AIA® Document G701™ – 2017

Change Order

PROJECT: *(Name and address)*
 Williamson County
 Animal Shelter Expansion
 1855 SE Inner Loop
 Georgetown, TX 78626

CHANGE ORDER INFORMATION:
 Change Order Number: 002

07 SECTION @ BREEZEWAY WALL HEAD
 1 1/2" = 1'-0"

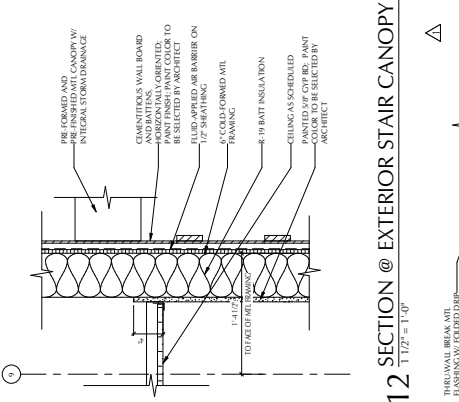
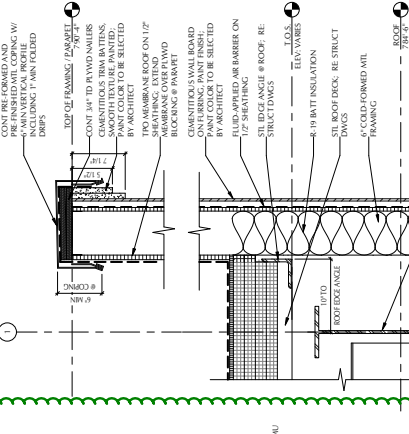
Detail 7/A.3-6.30 indicates the top of CMU to be 768'-6" at the breezeway wall head. Detail 2/S5.03 indicates a 3"x8" bent plate anchored 4" below the top of CMU and welded to the bottom of the beam. The bottom elevation of the beams running along Gridlines 2 and 3 is roughly 768'-11" resulting in a 5" space between the top of CMU wall and bottom of beam. The spacing between the CMU wall and beam is too large for the bent plate to span and maintain the epoxy bolt anchorage 4" below top of CMU. Please provide a revised detail for the CMU wall bracing at shear walls.

Structural detail 2/S5.03 governs. See revised detail 07/A.3-6.30, attached, which coordinates better with 2/S5.03.
